AGENDA PORTLAND PLANNING BOARD MEETING

Memorandum
Planning and Urban Development Department
Planning Division

To: Sean Dundon, Chair and Members of the Portland Planning Board
From: Christian Roadman, Planner
Date: June 21, 2019
Re: 95 Front Street, Residential Development
Project #: PL-000672-2019 CBL: 167 E001001, 167 E009001, 166 B001001
Meeting: June 25, 2019

PLAN CORRECTIONS REPORT PL-000672-2019 FOR CITY OF PORTLAND

Sheet No: **C-3.2**

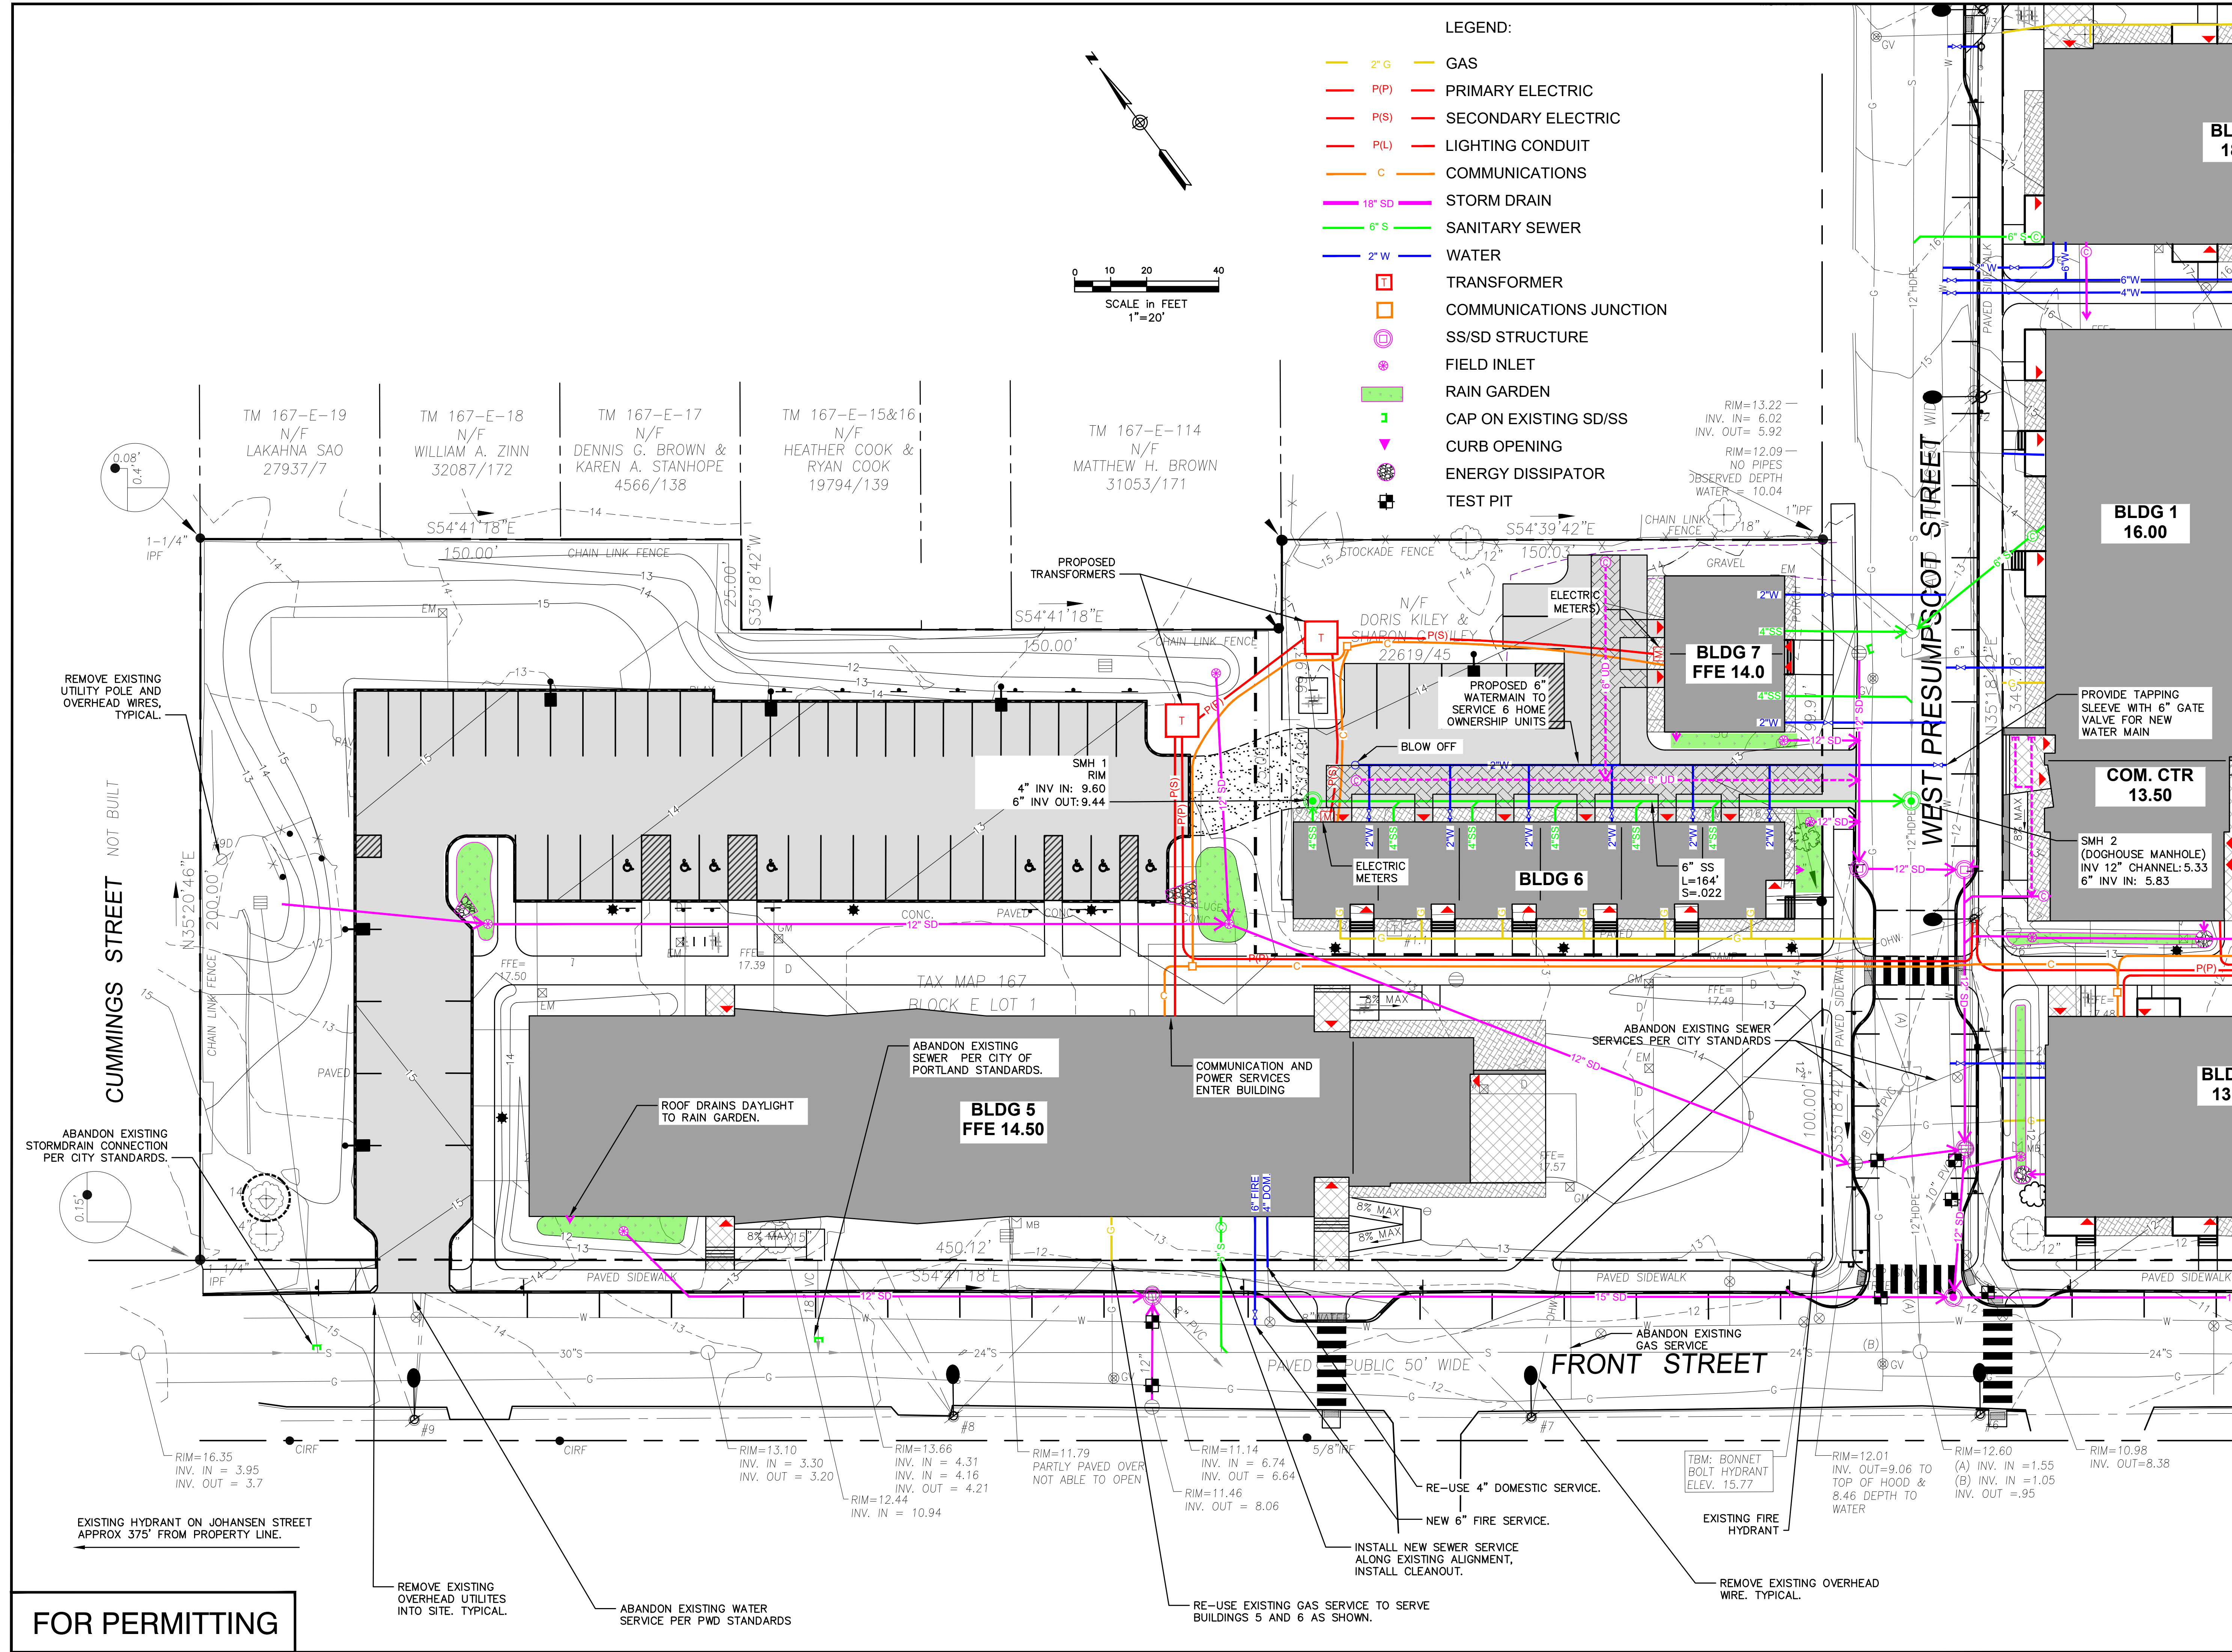
13. (Utilities): Verify that proposed stormdrain sizes are appropriate. Note that the system currently drains to a CSO, so "oversizing" stormdrain inlets is not necessarily inappropriate. Verify that utility crossings are possible given pipe sizes.

14. (Utilities): If bump-outs are removed or altered, reconsider catch basin locations.
15. (Grading): Spot grades are required to verify drainage, driveway dimensions, and ADA conditions. Please provide spot grades at high and low points, points of inflection, the top and base of curbs at regular intervals (including at inflection points at tipdowns and ramps), and anywhere else where they may be helpful.

STORMWATER PLAN

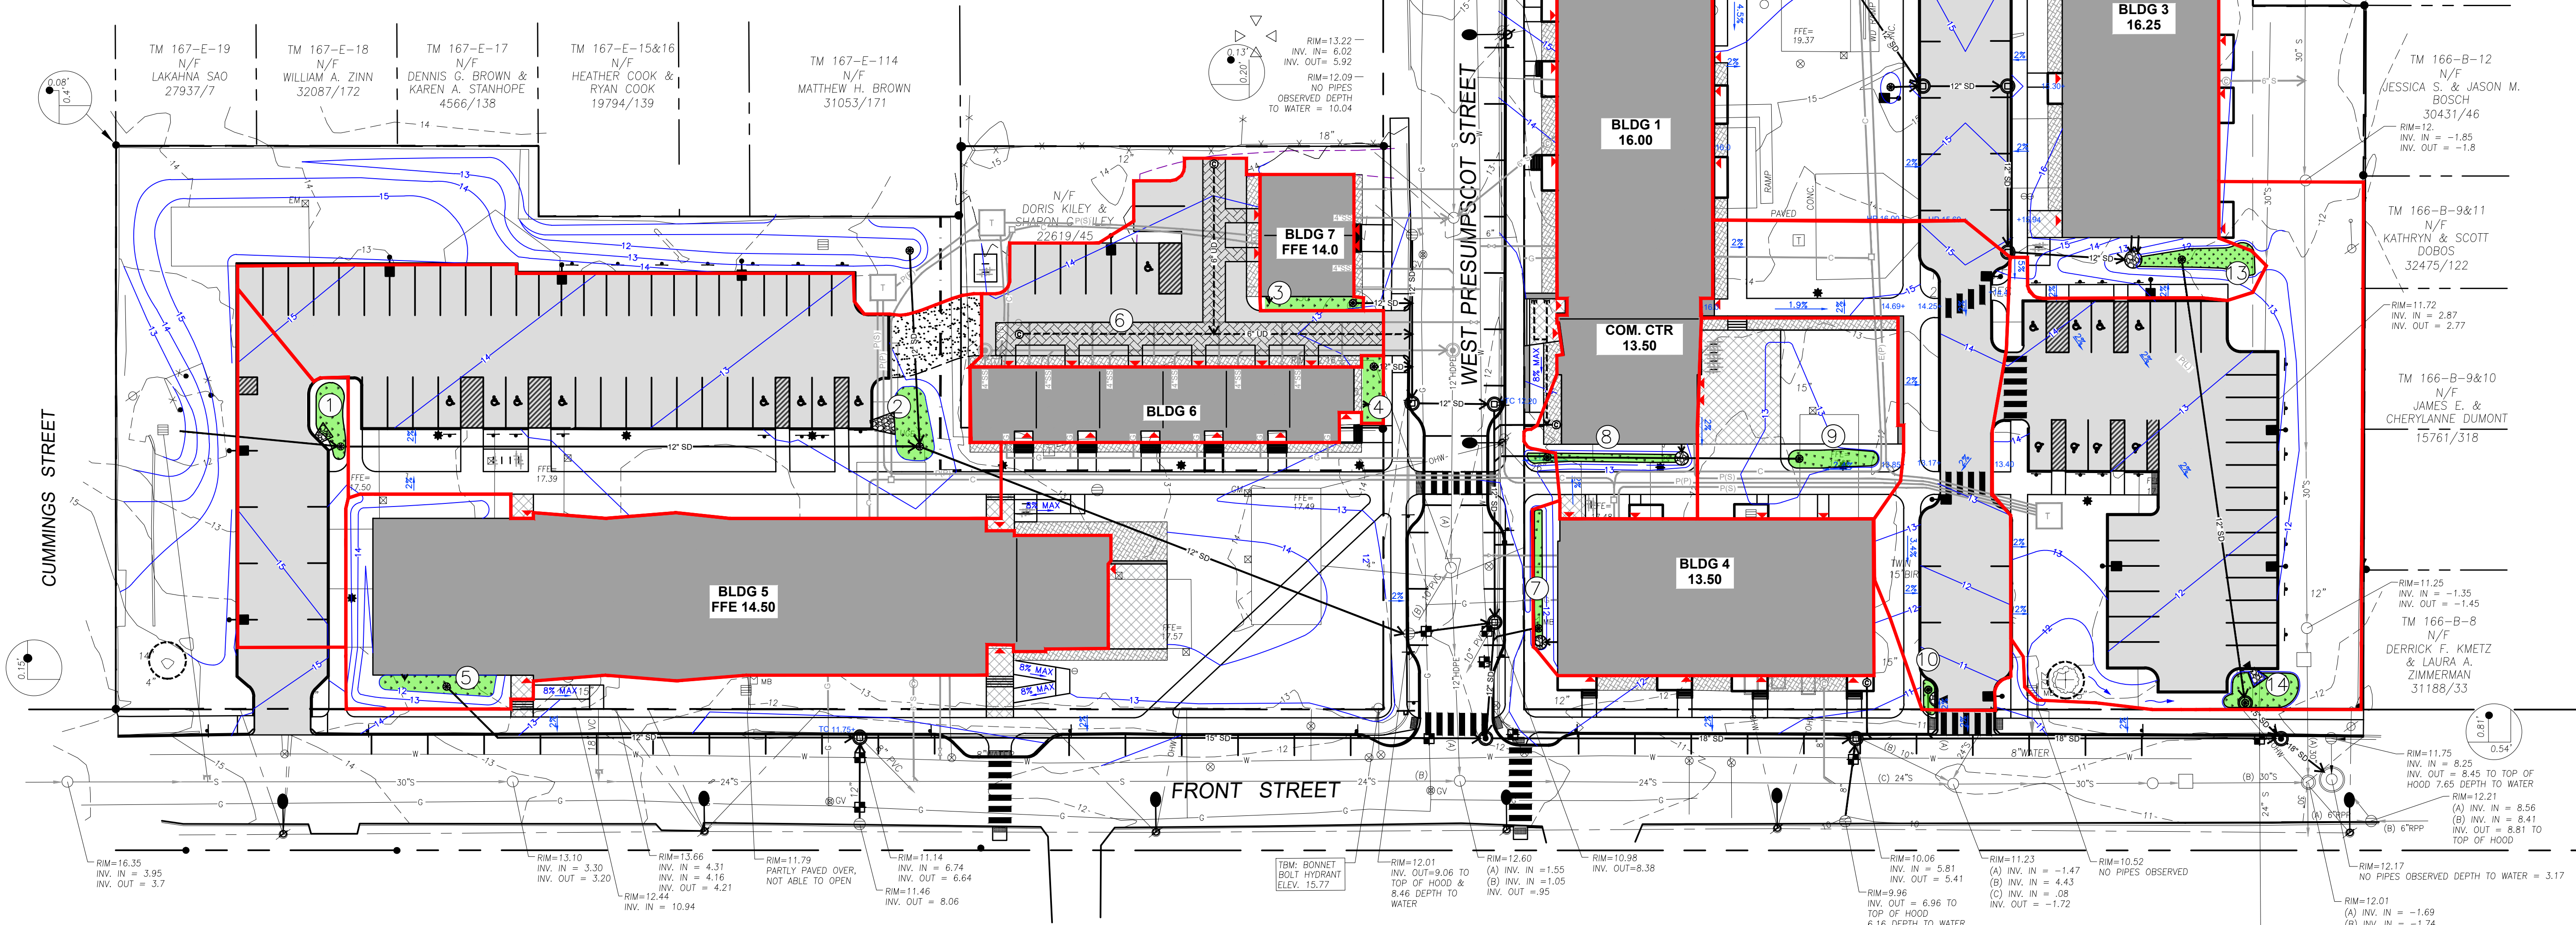
- The plans should provide additional clarity on the types of stormwater treatment used throughout the site, distinguishing between Focal Points and other underdrained soil filters. The plan should show the location and size of the R-Tanks, locations of all access structures, and the extent of the Focal Point versus rain garden should also be shown. I think that some of the terminology (rain garden, underdrained soil filters, bioretention, Focal Point) is used interchangeably, and the specific systems should be clarified.

- Roof drains are shown daylighting into the stormwater treatment areas. Erosion protection should be provided at these locations.
- The Applicant noted in their narrative that they will be increasing flow from the pre-development condition to the post-development condition, and has noted in the narrative that a waiver of the Flooding Standard will be required. This waiver request should be added to the waiver form. Once the calculations are provided we'll review the acceptability of the waiver relative to size of infrastructure between the project and the Back Cove outfall.

TYPICAL RAISED CROSSWALK DETAIL
NOT TO SCALE

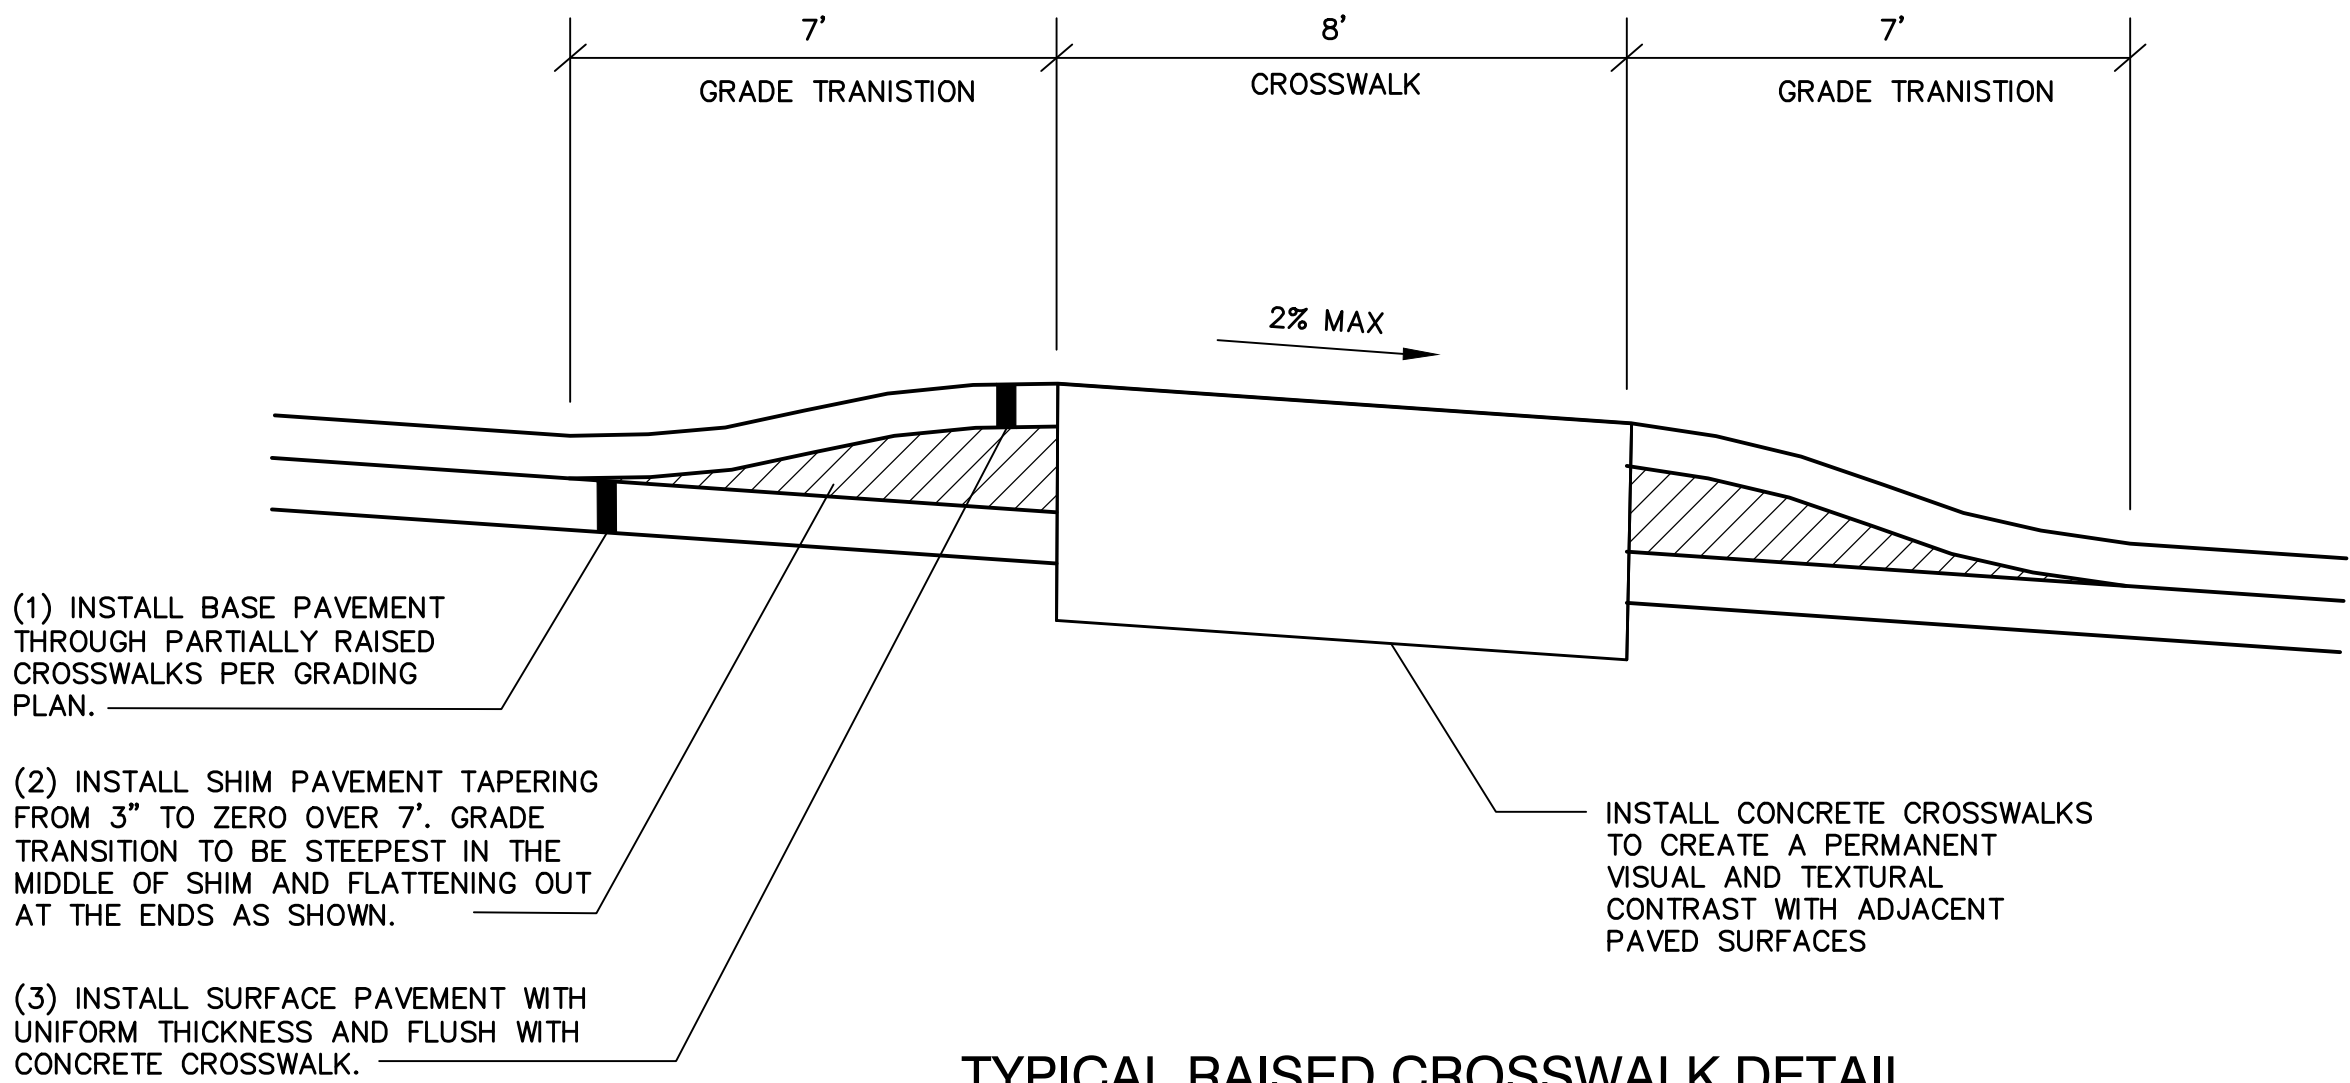
3. (General): The plans appear to show a raised crosswalk across West Presumpscot Street. DPW does not support the use of raised crosswalks on local streets.

Figure 3: Future Peak Demand with hotel (note. removal of monthly/transient parkers would reduce demand beneath supply).

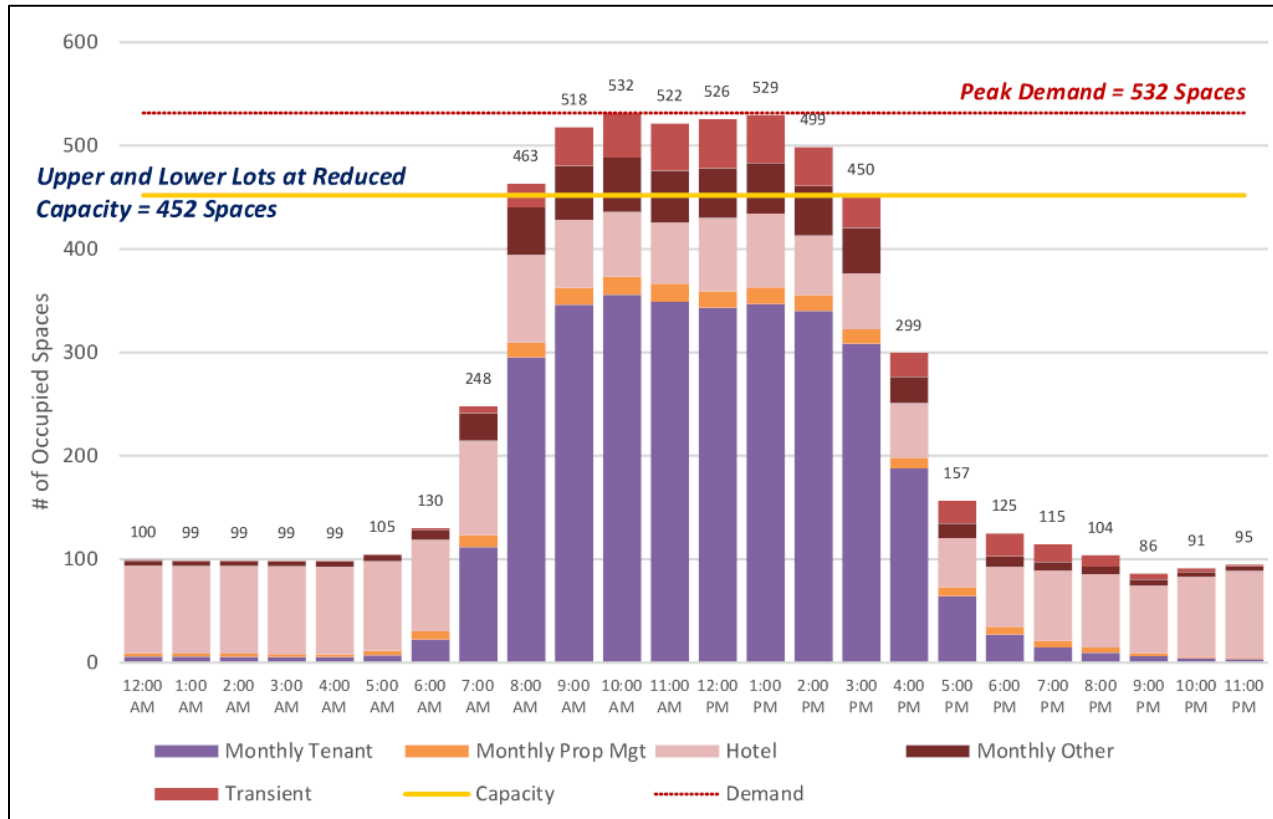
- A number of the data points in Figure 3 fall above the average line particularly during the late winter time period. Some discussion on the use of average conditions versus an 85th percentile conditions should be provided.
